HUMAN FACTORS ENGINEERING REVIEW AND EVALUATION

WEAPON SYSTEM 107A-2 LAUNCHER, OSTF AND TF-1

FINAL REPORT

HUMAN FACTORS ENGINEERING
REVIEW AND EVALUATION OF TITAN WEAPON
SYSTEM 107A-2 LAUNCHER, OSTF & TF-1
FINAL REPORT

FIGURE 8-1
HUMAN FACTORS INPUTS
COMMUNICATIONS SYSTEM

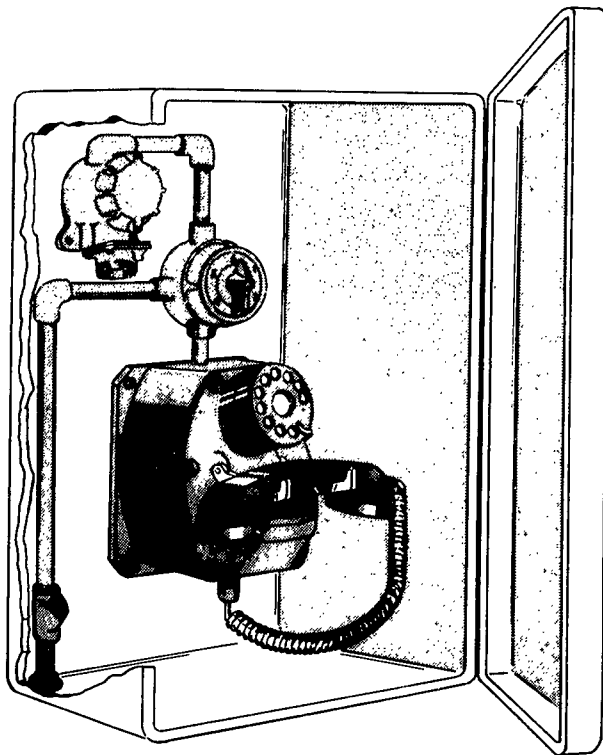
CONTROL-DISPLAY HEIGHTS

The personnel elevator telephone should be located within tolerance limits with respect to operator's hand and eye heights.

STATION LOCATIONS

Telephone stations are mounted in accessible locations recommended in AMF drawing #150-268.

FIGURE 11-1
HUMAN FACTORS INPUTS
CRIB-TO-SILO BRIDGE

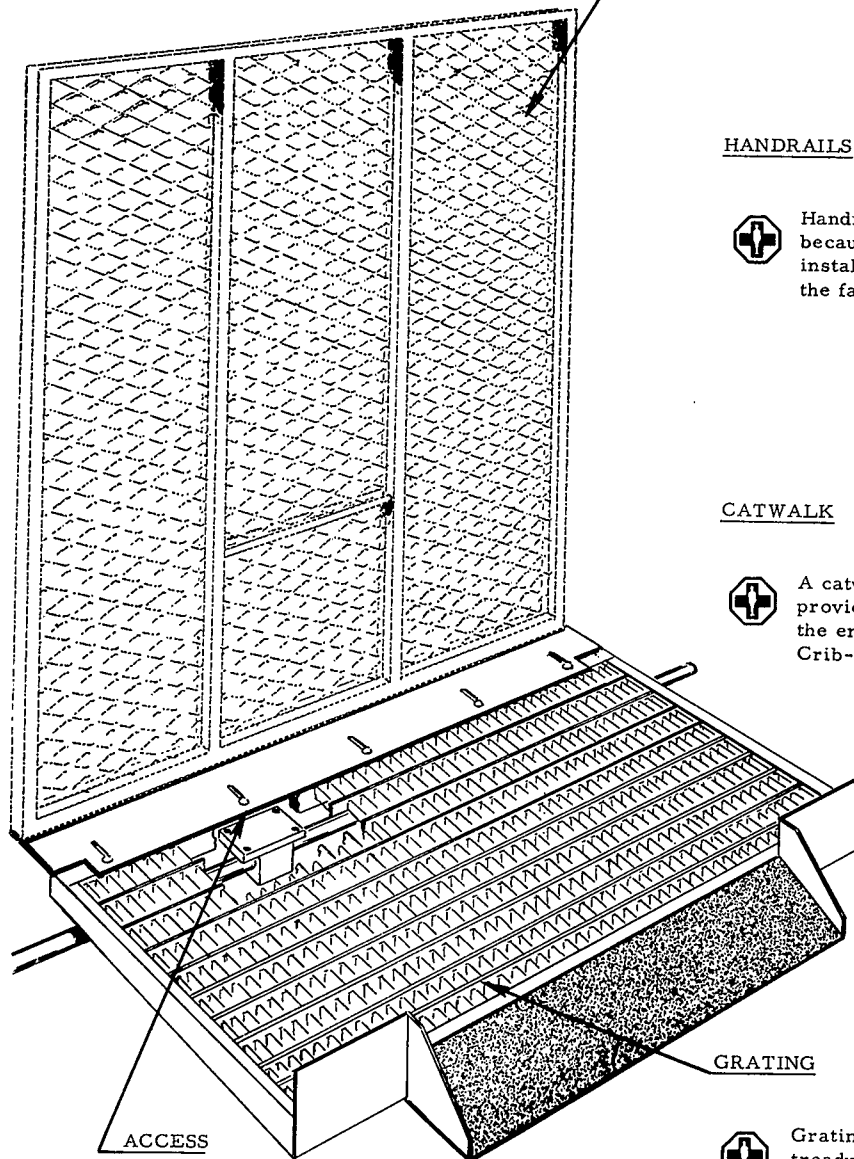
The bridge dimensions provide adequate area for the movement of the men and equipment to be transported from the Personnel Tunnel to the Personnel Elevator.

A gate has been added to protect personnel from the danger of the open elevator shaftway.

HANDRAILS

Handrails have been removed because associate contractor installations have eliminated the falling hazard.

CATWALK

A catwalk has been added to provide safe passage between the emergency ladder and the Crib-To-Silo Bridge.

FIGURE 12-1
HUMAN FACTORS INPUTS
LIFTING AND HANDLING DEVICES

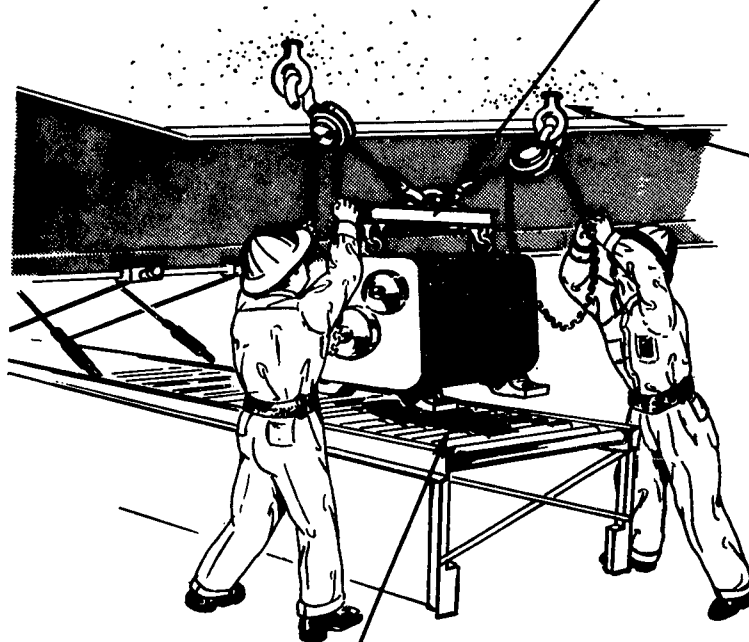
COMPONENT WEIGHTS

Strongbacks have been recommended to distribute heavy loads evenly.

All components which are above the safe limit for a man to lift must be provided with some special handling means.

FIGURE 13-1
HUMAN FACTORS INPUTS
TRAILER, LIFT & MAINTENANCE
DOLLY

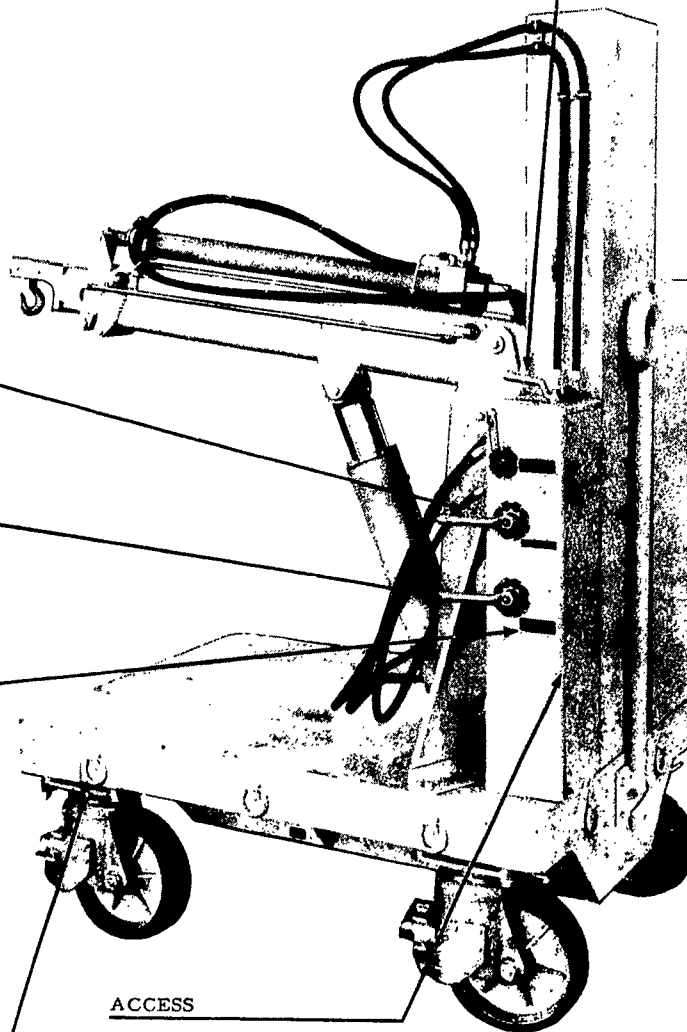
CAPACITY

Warning signs shall indicate load capacities and proper hydraulic fluids.

FIGURE 13-1
HUMAN FACTORS INPUTS
TRAILER, LIFT & MAINTENANCE
DOLLY

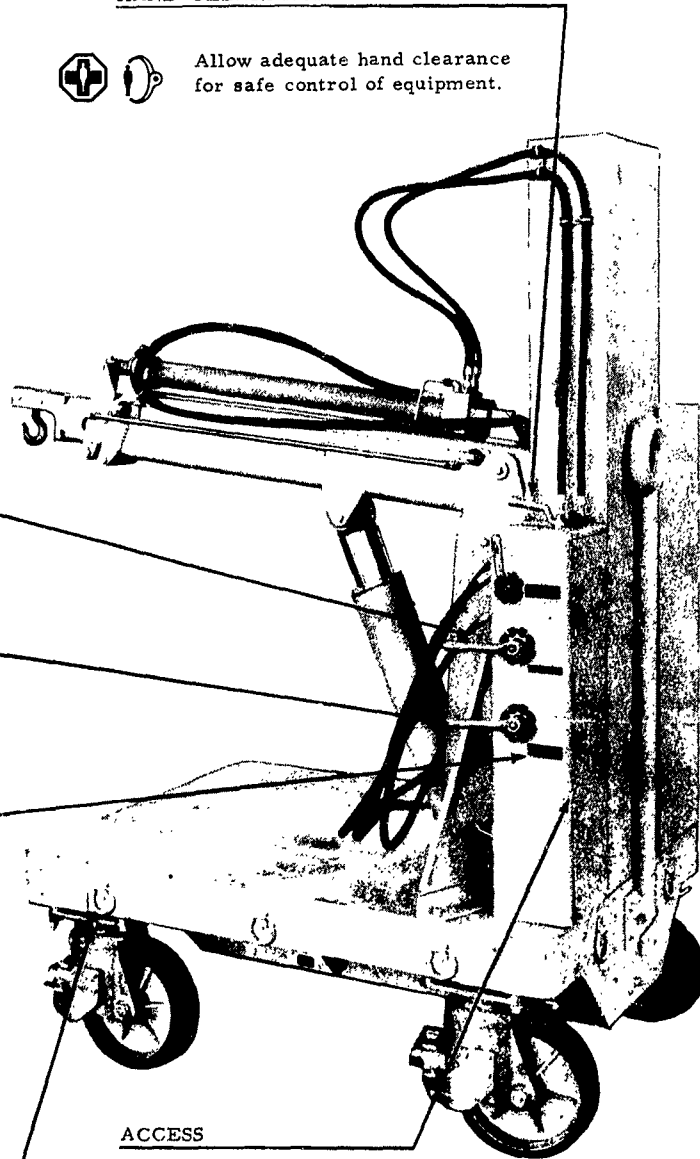
CAPACITY

Warning signs shall indicate load capacities and proper hydraulic fluids.

FIGURE 14-1
HUMAN FACTORS INPUTS
MISSILE EMPLACEMENT

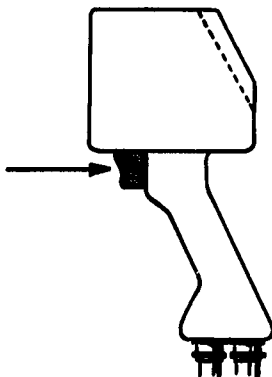
CONTROLS

Arrangement of controls should be consistent from application to application.

FIGURE 14-2
HUMAN FACTORS INPUTS
COLES CRANE

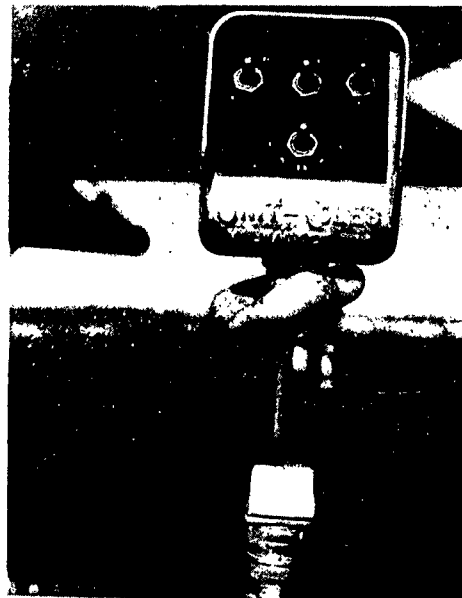
DEAD-MAN CONTROL

A dead-man trigger switch has been provided to insure fail safe conditions.

FIGURE 14-3
HUMAN FACTORS INPUTS
SILO MOUTH PLATFORMS
AND
TAG LINE WINCHES

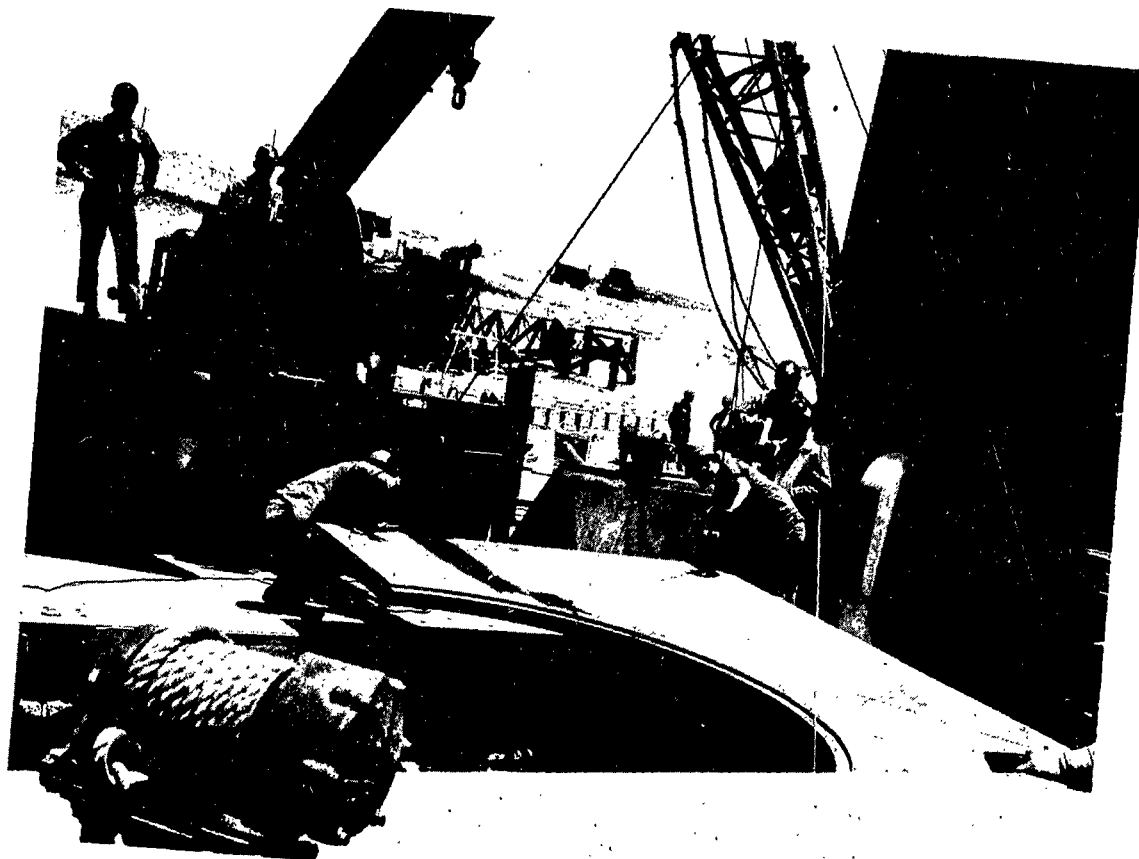
WINCHES

Tag line winches should be located for optimum standing operation of the crank.
